INFORMAL GROUP ON GASEOUS FUEL VEHICLES
Within the UN GRPE (WP29)
PROPOSED AMENDMENT GFV-02-04

Regulation name and reference number: Regulation 115

Proposals for Draft Amendment and Comments to Regulation 115

Fig. 1. Switch over time for some retrofit system/vehicle combinations
 (Source: Environmental Protection Division, Motor Transport Institute, Warsaw, Poland)

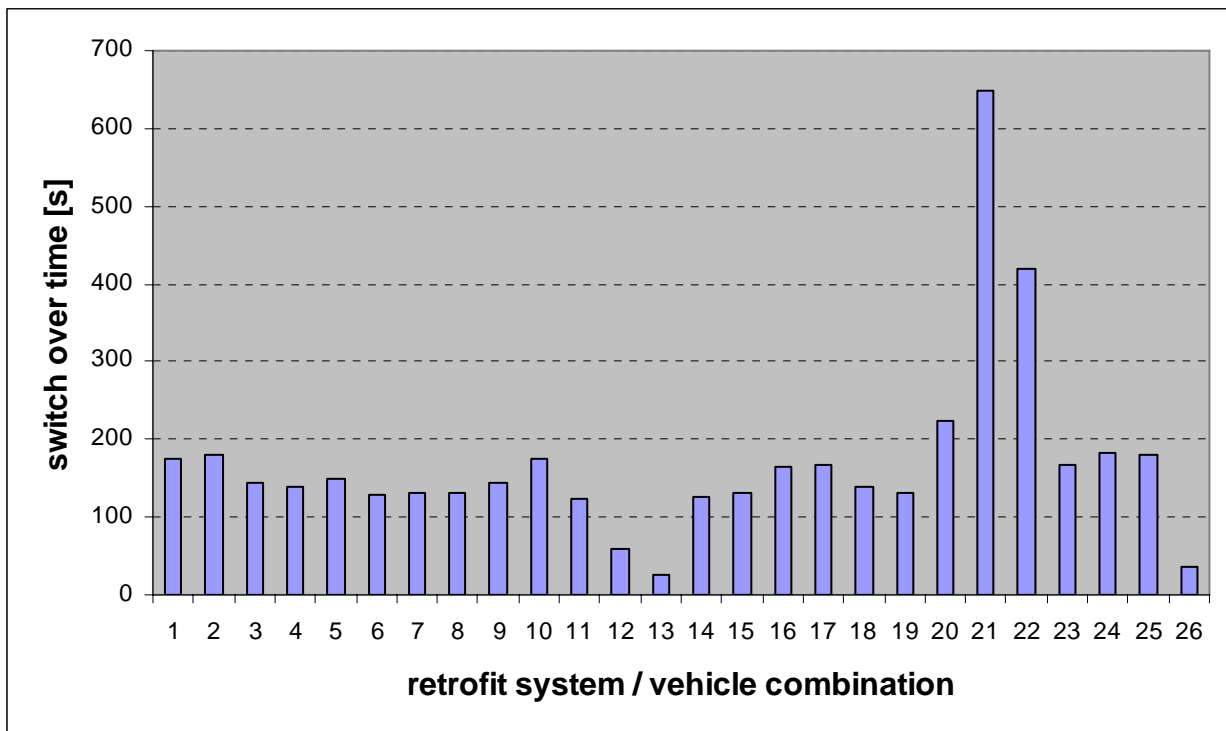
(vii) In LPG mode the switch over from petrol fuelling to LPG fuelling in the type 1 test occurs after some time. The switch over time of some retrofit system/vehicle combinations submitted for the type-approval in Poland is shown in Figure 1.

This switch over time varies from 25 s to 648 s. It seems that this time in some retrofit systems is made longer than required to reduce the emission in LPG mode in the type 1 test and consequently to make it possible to comply with the requirements in force.

Fig. 2. Relative emission versus time for vehicle A in the urban part of the type 1 test
 (Source: Environmental Protection Division, Motor Transport Institute, Warsaw, Poland)

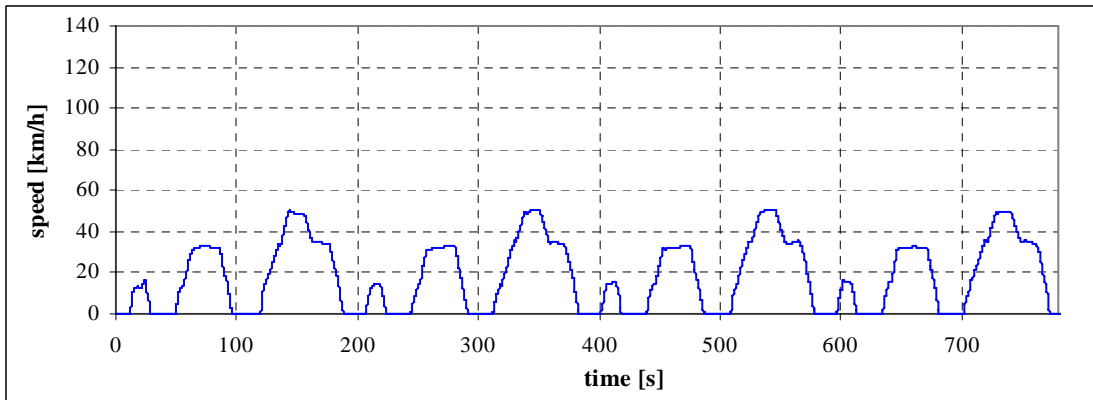
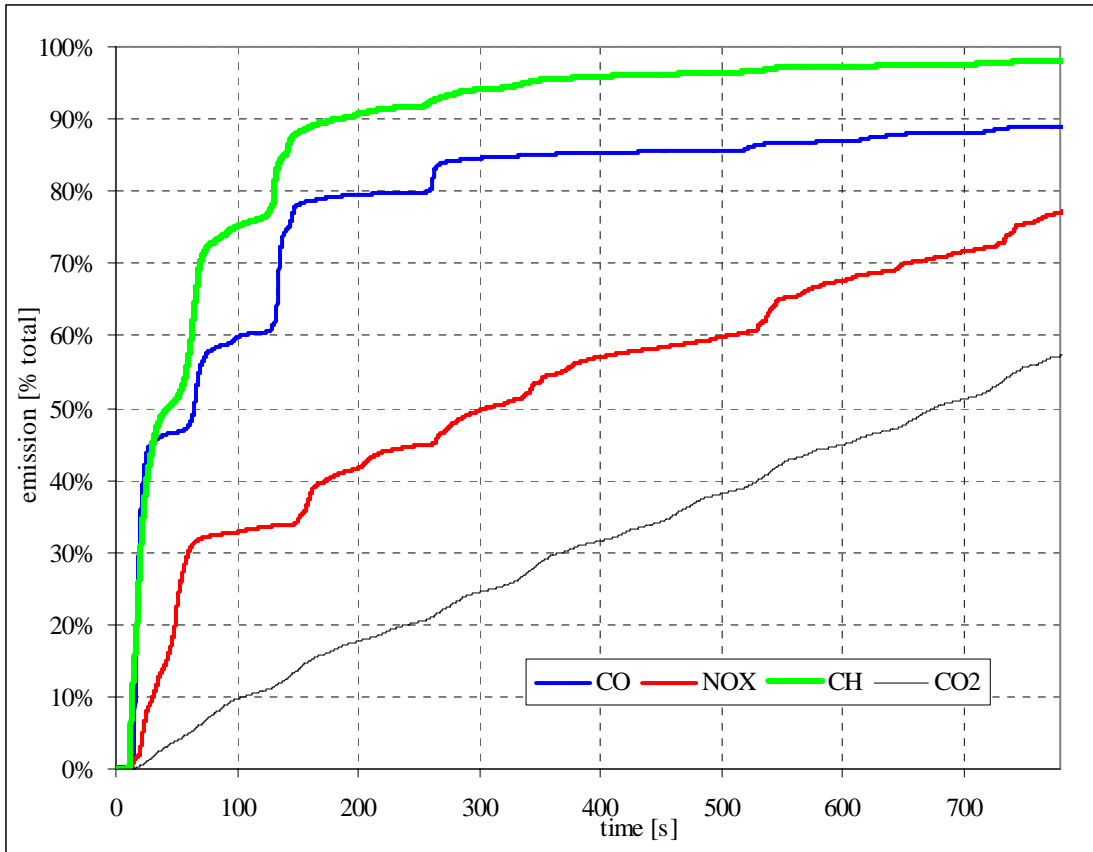
Figures 2 and 3 show the relative emission in the urban cycle (the total value measured over the whole type 1 test = 100%) versus time for 2 vehicles converted to LPG. Such curves are typical for Euro 3 and Euro 4 vehicles.

Fig. 4. LPG/petrol emission ratio for different ratio of actual emission with petrol to limit (40%, 60% 80%, 100%) for “non-intrusive” retrofit system

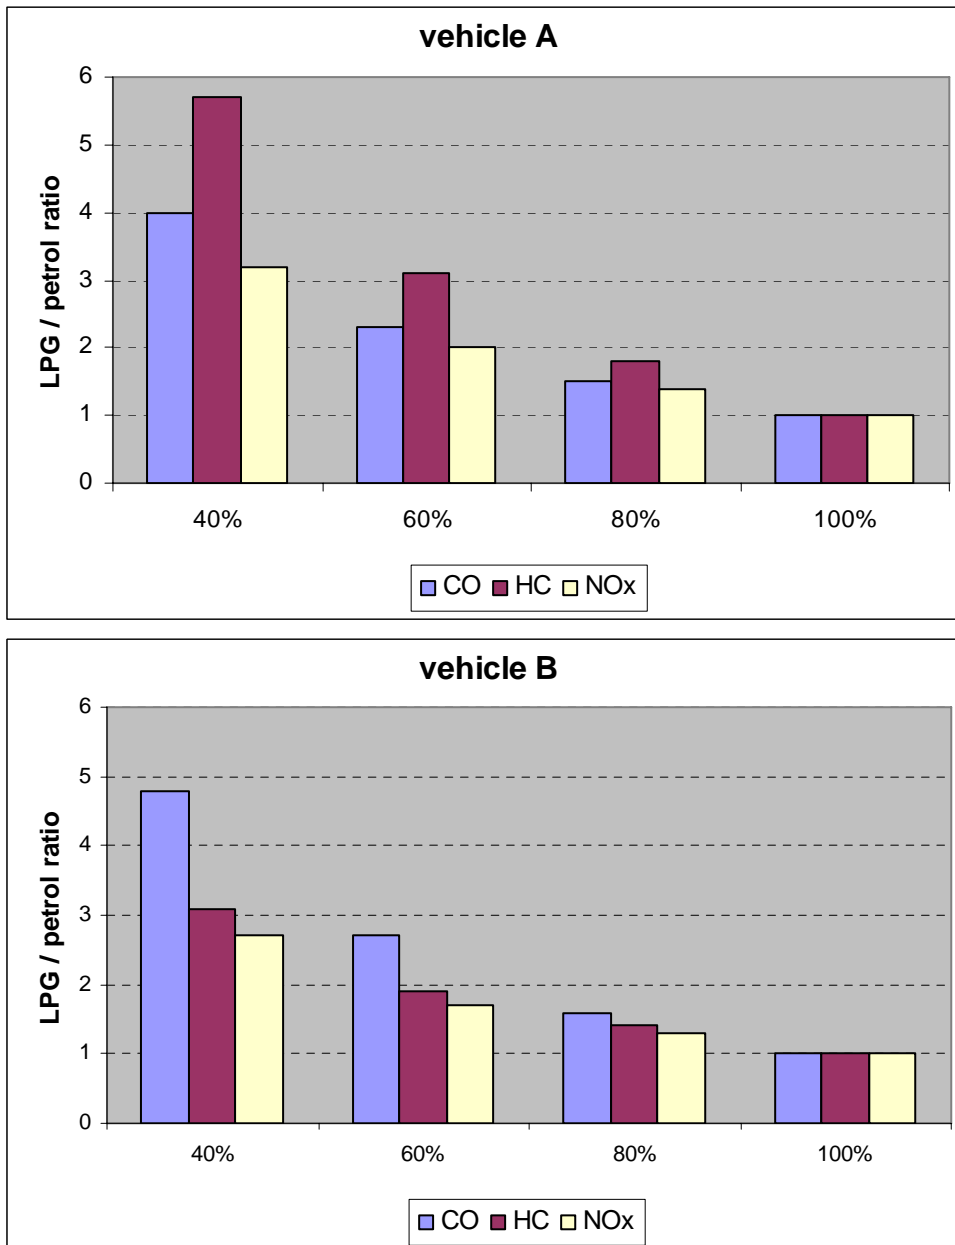
The LPG/petrol emission ratio is shown in Figure 4.

The ratio of the actual emission to the limit value is usually in the order of 40% - 60% for Euro 3 and Euro 4 vehicles. If it is equal to 40%, the relative emission versus time curve is similar to those shown in Figures 2 and 3 and the switch over time is 60 s, the emission with LPG may be even about 5 times higher than that with petrol and the vehicle is deemed to comply with the requirements of Regulation 115 for “non-intrusive” retrofit systems.

Fig. 5. LPG/petrol emission ration versus switch over time for different ratio of actual emission with petrol to limit (40%, 60% 80%, 100%) for “non-intrusive” retrofit system (HC, vehicle A)

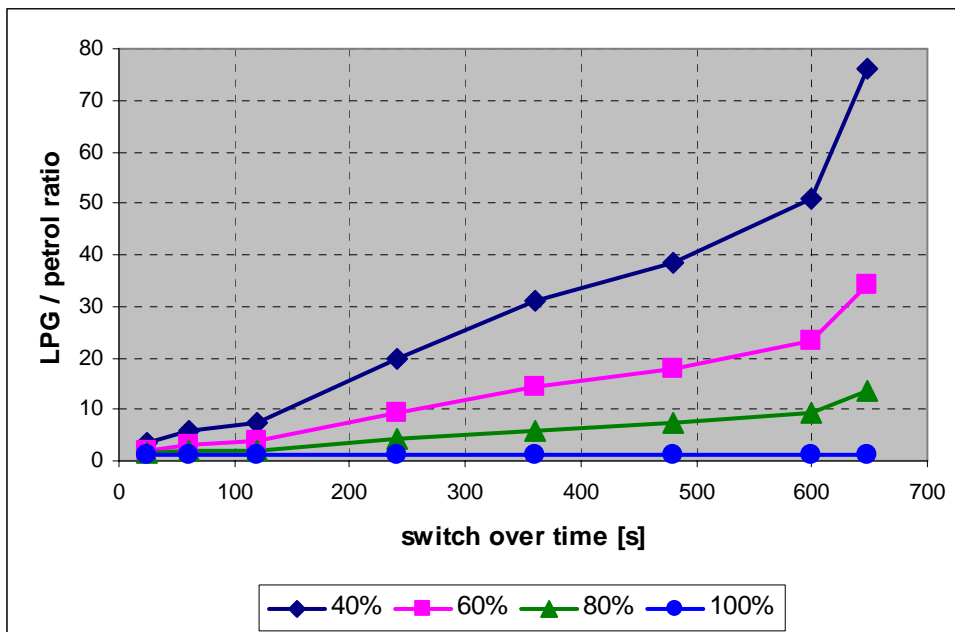
Figure 5 shows the effect of the switch over time on the LPG/petrol emission ratio for HC (vehicle A).

In Figure 5 the switch over time varies from 25 s (the shortest time in Figure 1) to 648 s (the longest time in Figure 1). If the ratio of the actual emission to the limit value is 40 %, the switch over time is 648 s and the relative emission versus time curve is similar to that shown in Figures 2, **the emission with LPG may be even 70 times higher than that with petrol and the vehicle is deemed to comply with the requirements of Regulation 115 for “non-intrusive” retrofit systems.** Even when the switch over time is 25 s, the emission with LPG may be 3 times higher.

LPG is believed to be a “clean” fuel. It has several features that can contribute to the reduction of emission. However they are not taken advantage of in the current Regulation 115. The emission with LPG may be several, in extreme case even more than 70, times higher than that with petrol (Figure 5) and the system passes the tests.

(i) The following paragraphs should be deleted:

- 2.1.5,
- 3.2.5,
- 5.2,
- 6.1.2.2,
- 6.1.2.5.1.4,
- 6.1.2.5.1.4.1,
- 6.1.2.5.1.4.2,
- 6.1.2.5.3.4,

- 6.1.3.4,
- Annex 1A, item 11.1, the second line,
- Annex 3A, item 2.4.
